**Shatin to Central Link  
Mong Kok East to Hung Hom Section  
(EP-437/2012/A)**

Visual, Landscape, Tree Planting  
and Tree Protection Plan

Version K June 2023

**FIGURE B1 - SITE LOCATION PLAN - (SHEET 1 OF 3)**

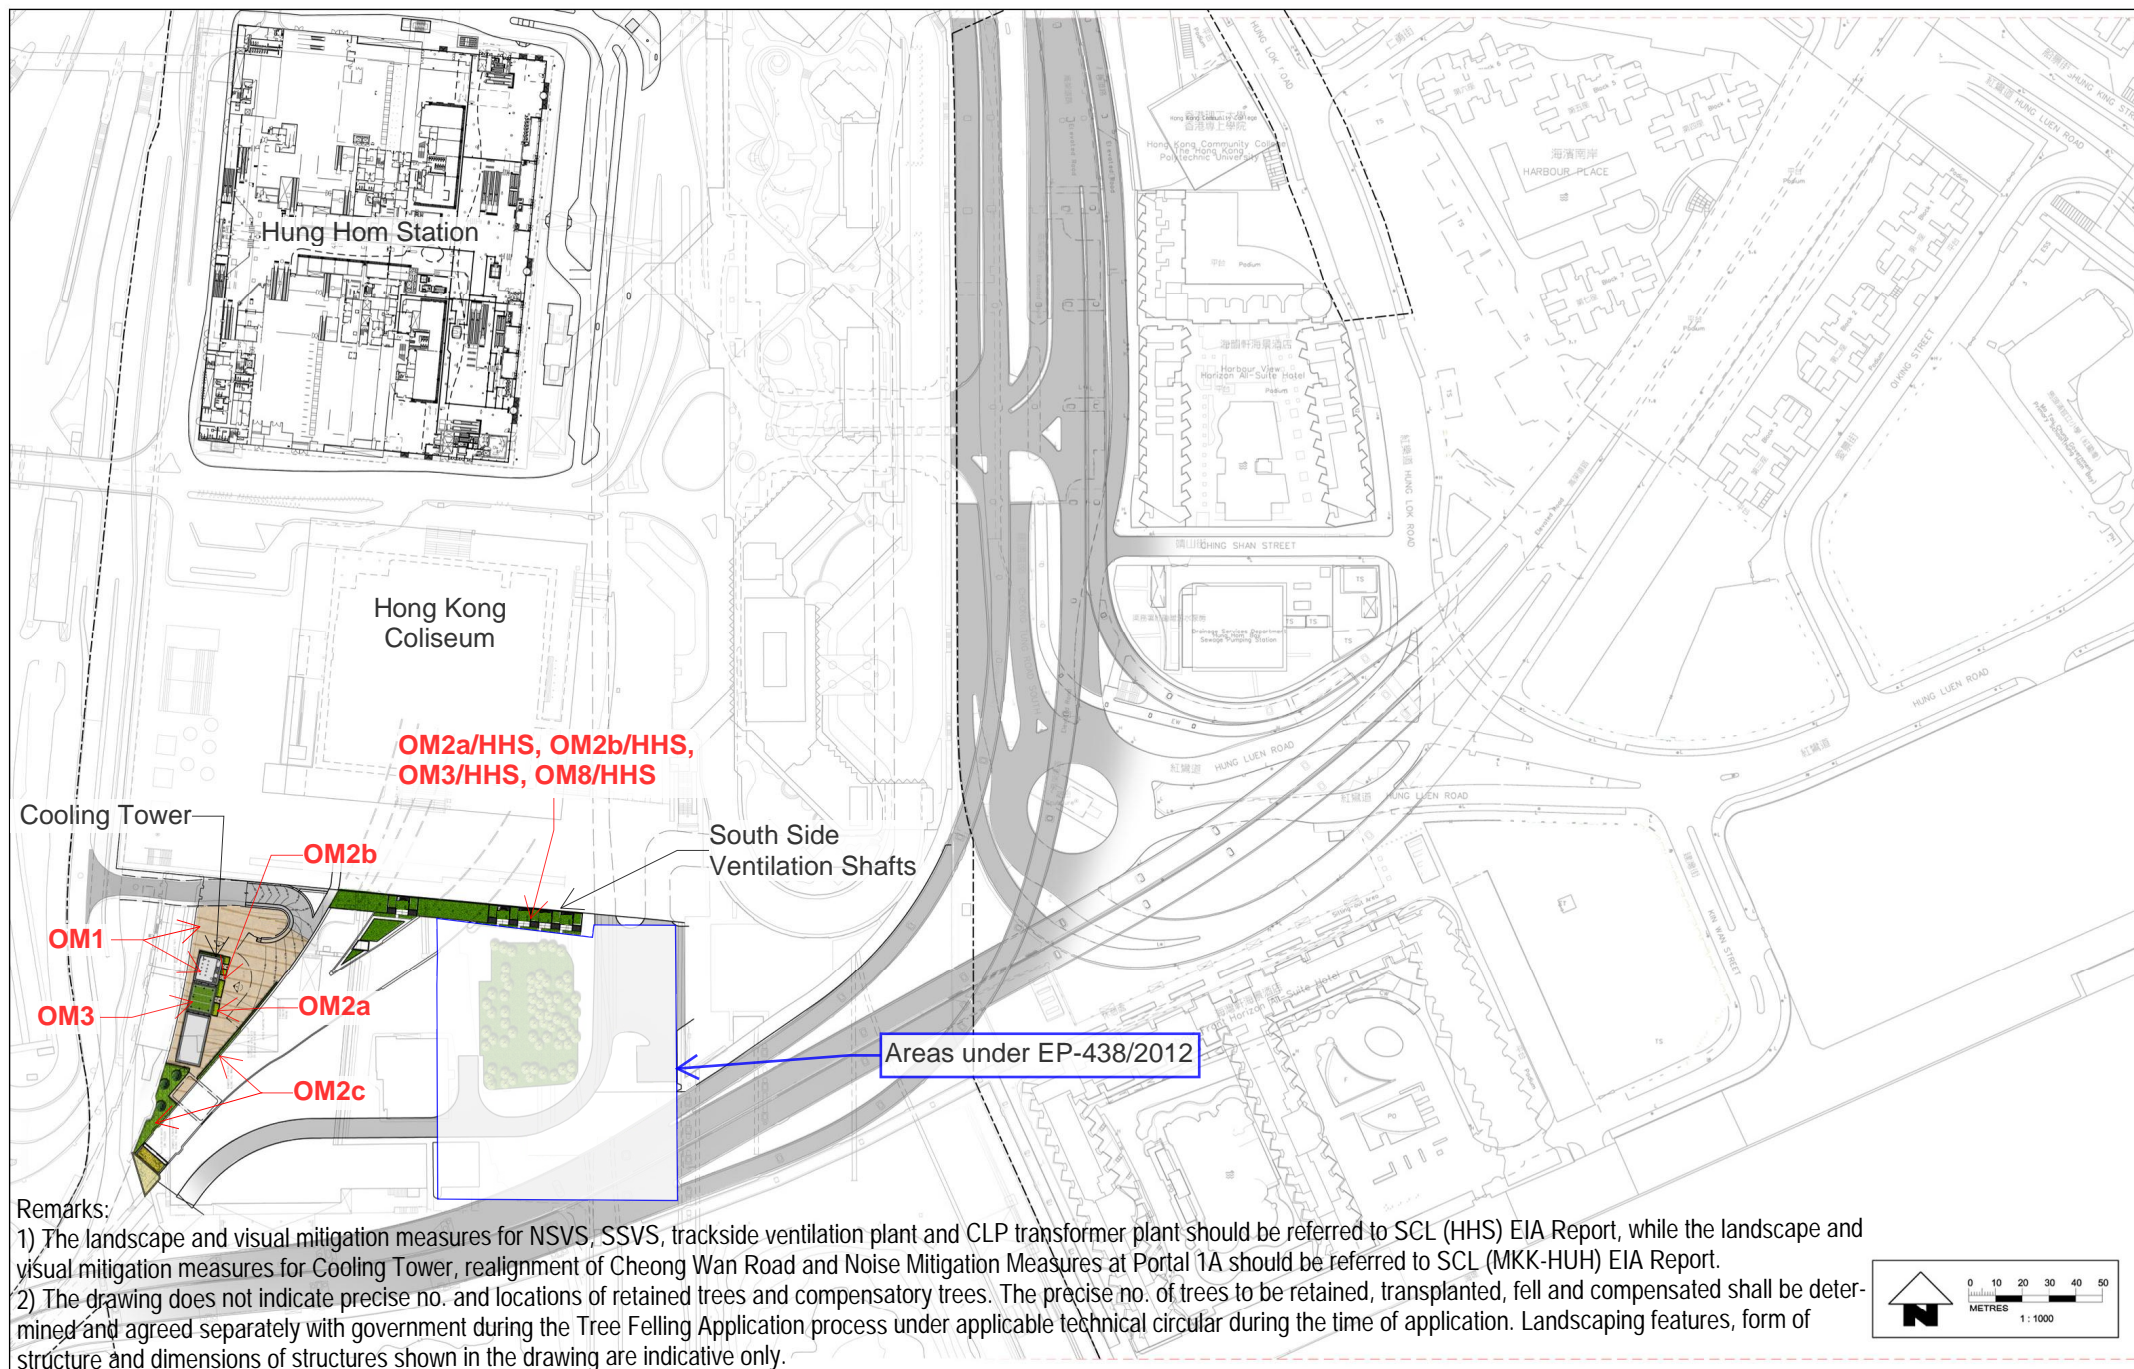
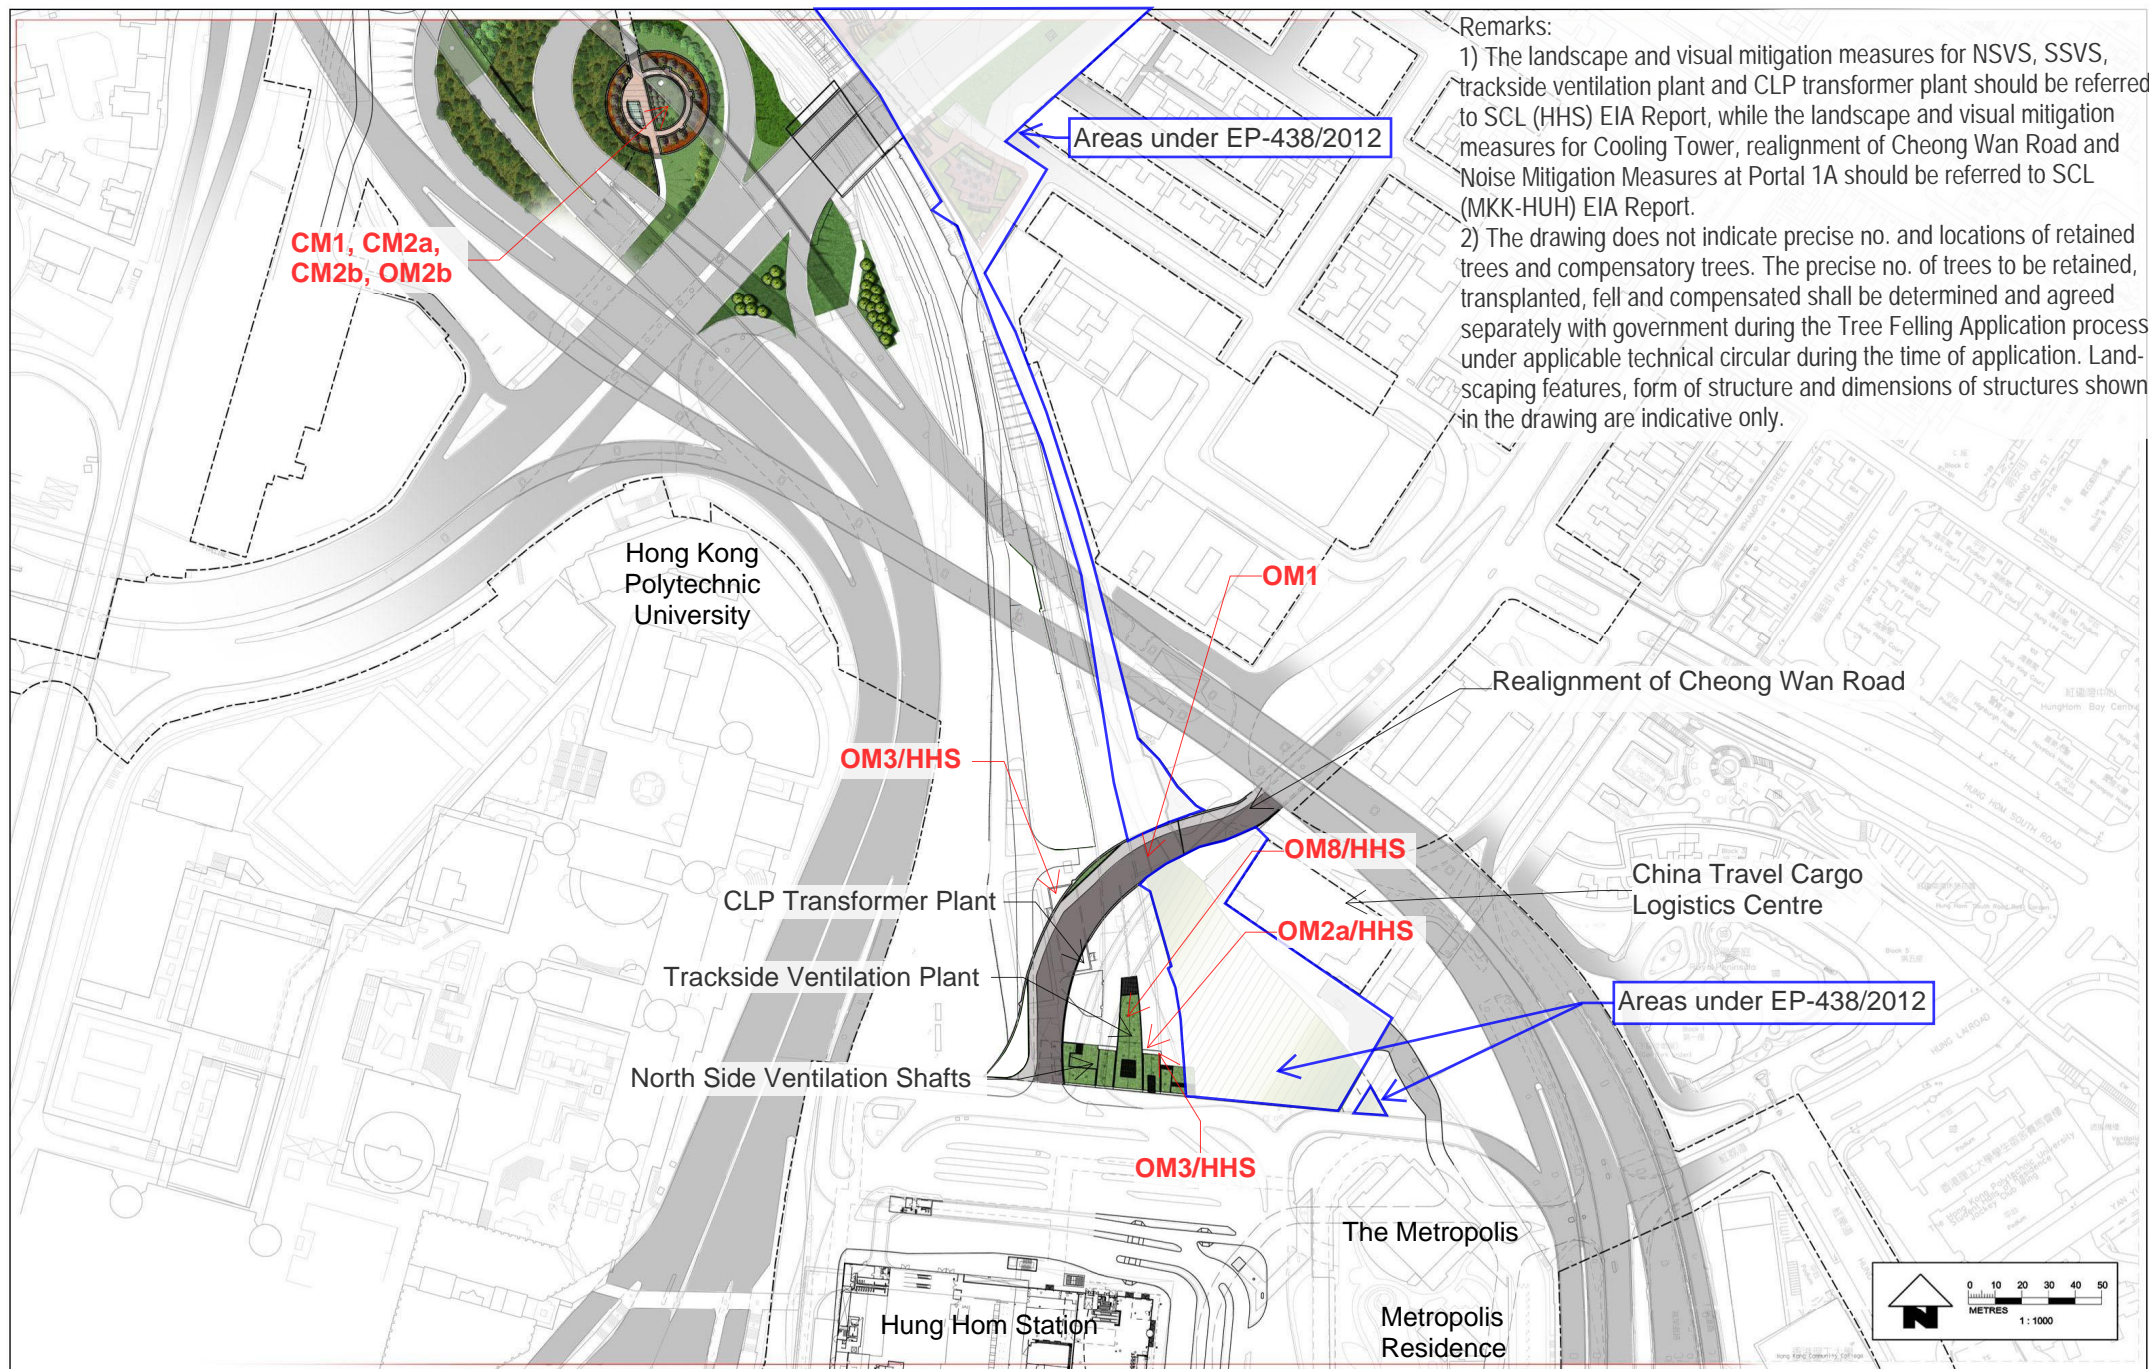
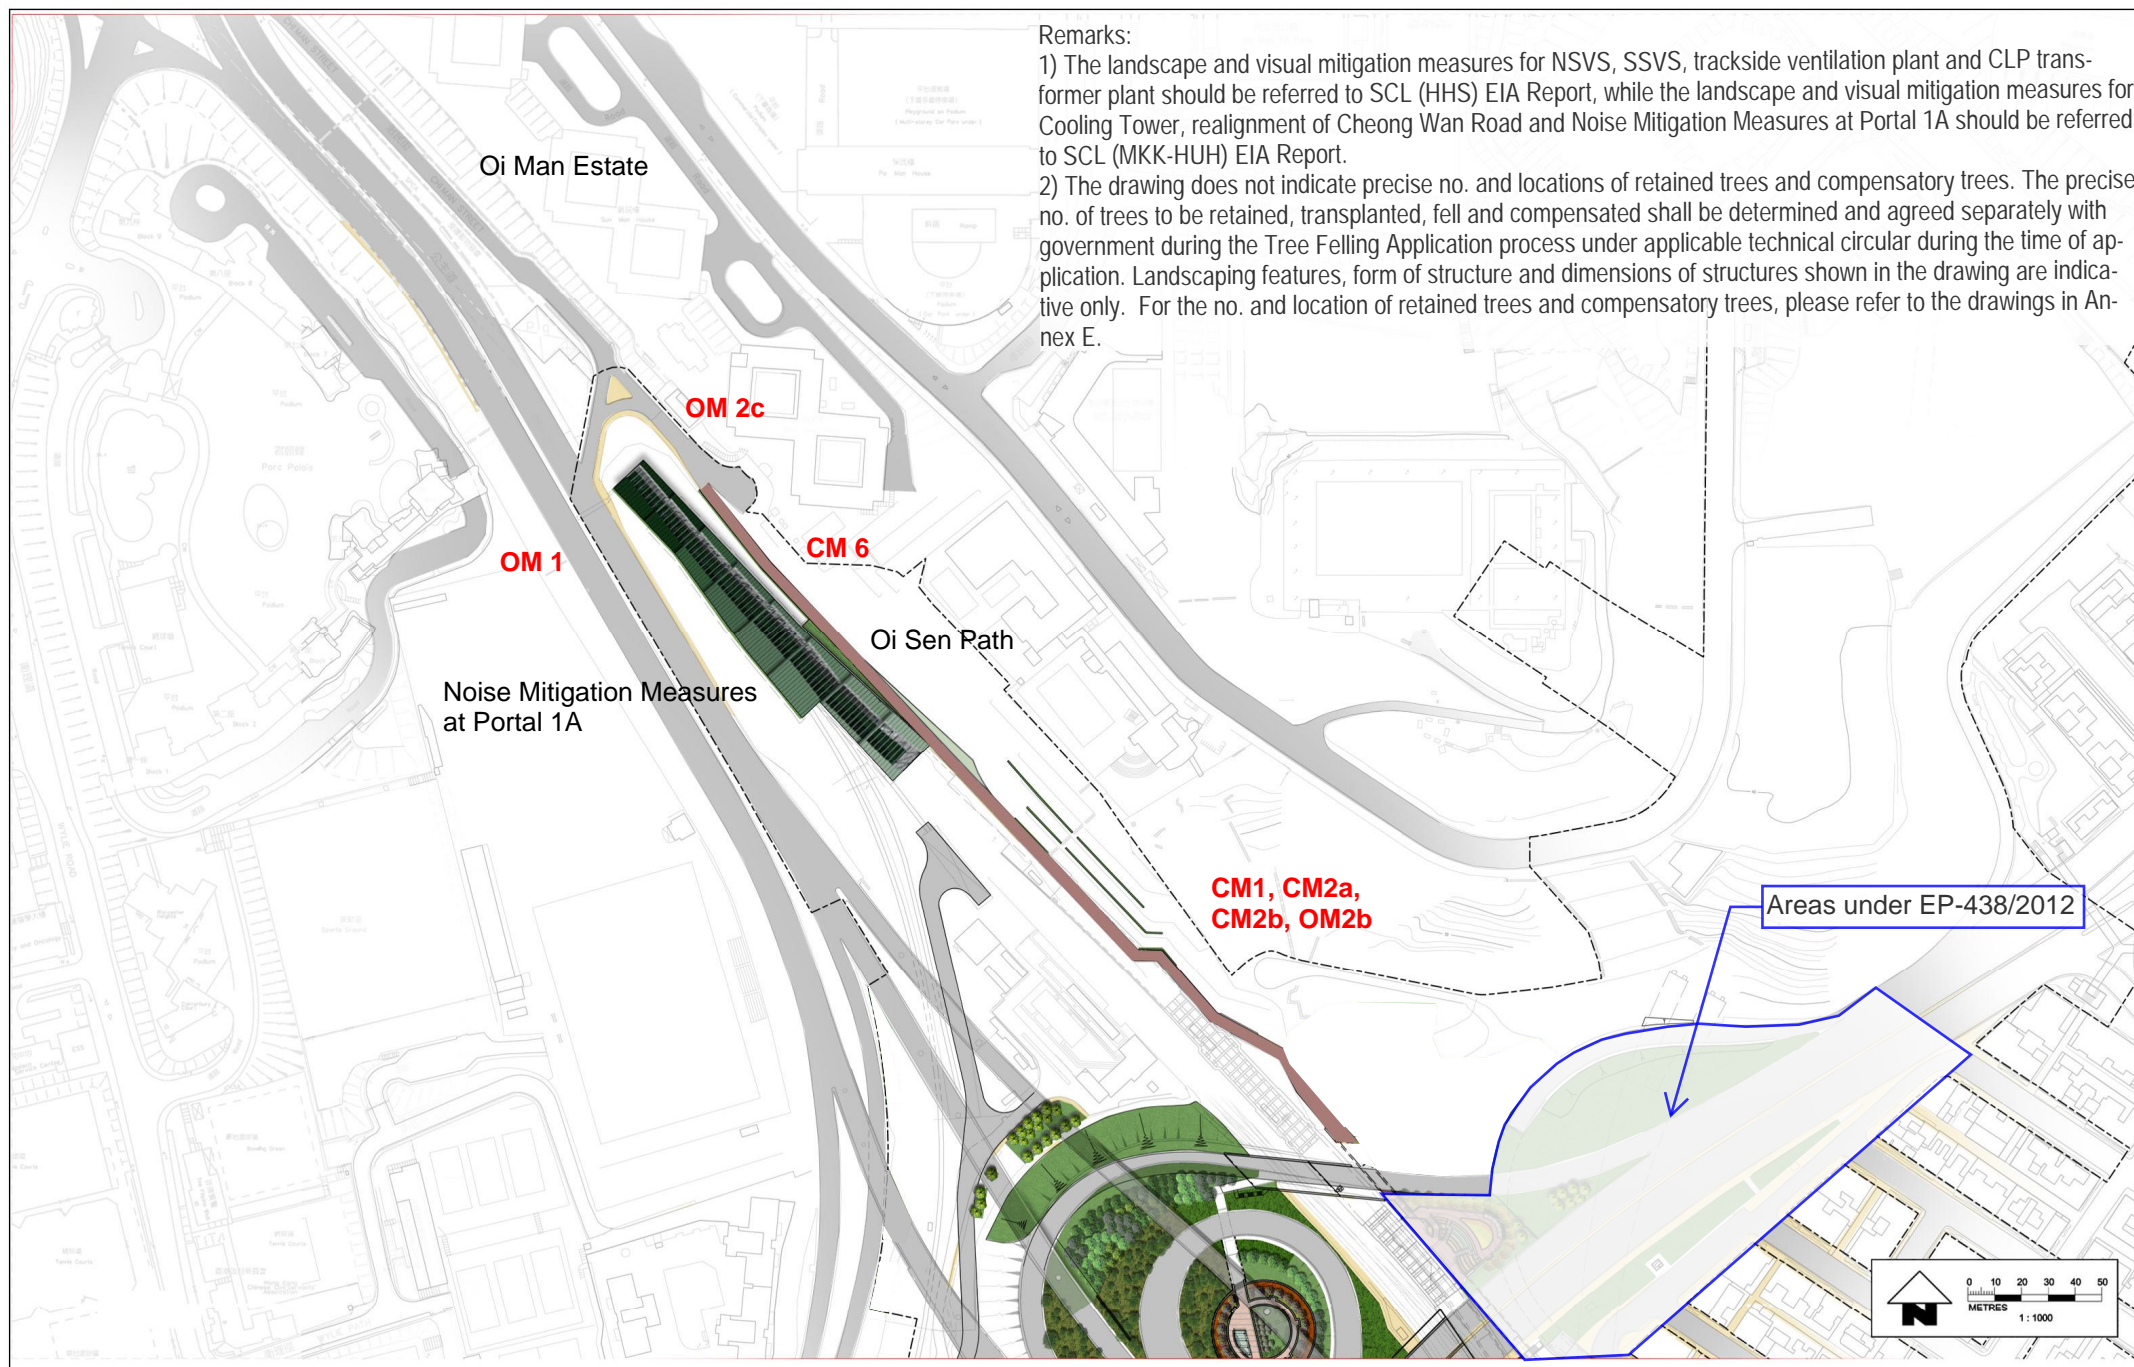
m.	W.r.t. "Site Location Plan (sheet 1 to 3)", when compared with Dwg. No. NEX2213/C/361/ENS/M54/552(A) to 554(A) under AEIAR-165/2012, considerable quantity of possible retained trees and CM2a (compensatory trees and shrub) at various road verges areas are missing without justification. Effectiveness of CM2a is in doubt.	<p>Please note that tree compensation on the slope areas are not allowed based on latest comments from relevant Government Department. Also, the areas of man-made slope at Chatham Road North (LR10) and part of amenity areas at Oi Sen Path (LR2) will be developed as new Campus Extension Development (including residential institution and educational institution) of the Hong Kong Polytechnic University (HKPU). Compensatory planting therefore cannot be provided on-site due to programme mismatch between SCL and the proposed Campus Extension Development. Nevertheless, landscape provision and open space with tree planting will be provided at this GIC site (<a href="https://www2.ozp.tpb.gov.hk/gist/apply/en_tc/A_K7_111_TC.pdf">https://www2.ozp.tpb.gov.hk/gist/apply/en_tc/A_K7_111_TC.pdf</a>) which could minimise the impact on the respective LRs in year 10 operation. New notes (4) to (6) has been added in Table 3.1 of revised VLTTP to explain the latest site situations.</p> <p>All the feasible tree planting opportunities within the site have been exhausted for on-site compensatory tree planting (CM2a). Alternative option, off-site tree compensatory planting at Hong Kong Boundary Crossing Facilities (HKBCF), Hong Kong-Zhuhai-Macao Bridge (HZMB), is therefore proposed for providing adequate tree compensation as far as practicable. The compensatory tree proposal in HKBCF including locations and numbers could be referred to Attachment B. For other information such as tree sizes and species etc., will be subject to the final landscape design of the HKBCF project and shall be to the satisfaction of HZMB and relevant authorities or parties.</p>

n.	Drawing / figure no. for "Site Location Plan" (sheet 1 to 3) should be assigned and marked on plans for easy reference and proper record.	Noted. Figure Nos. have been assigned for easy reference.
	<u>(l) Noise Mitigation Measures at Portal 1A and Realignment of Cheong Wan Road</u>

**GREEN ROOF**  
SCALE N.T.S.

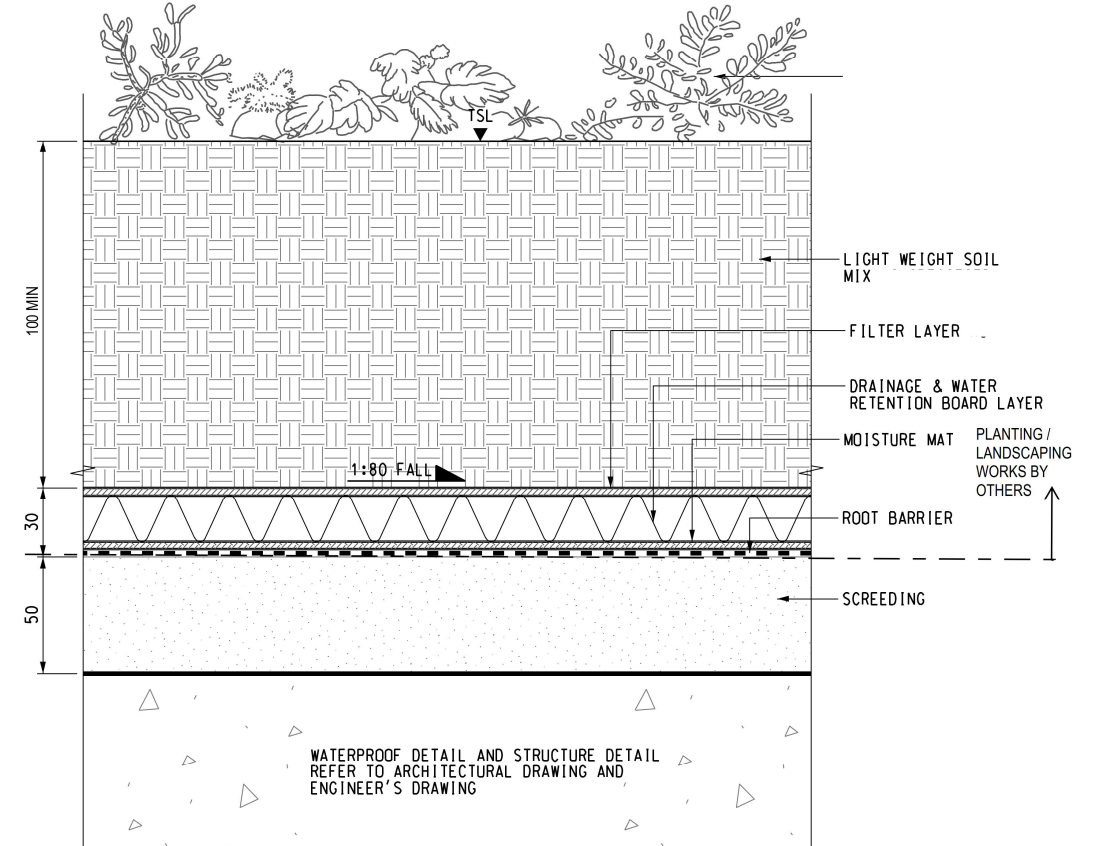
- (5) Minimum planter width and soil depth can vary between few hundreds to a thousand of millimetres subject to different plant species and area. All amenity planting in small area was avoided during the design stage and all planting will be undertaken in accordance with good horticultural practice. A typical drawing showing minimum planter width and soil depth is provided in Annex Figure H-1 for reference.

- (6) A typical section on roof greening above the Station is shown in Annex Figure H-1 for reference.
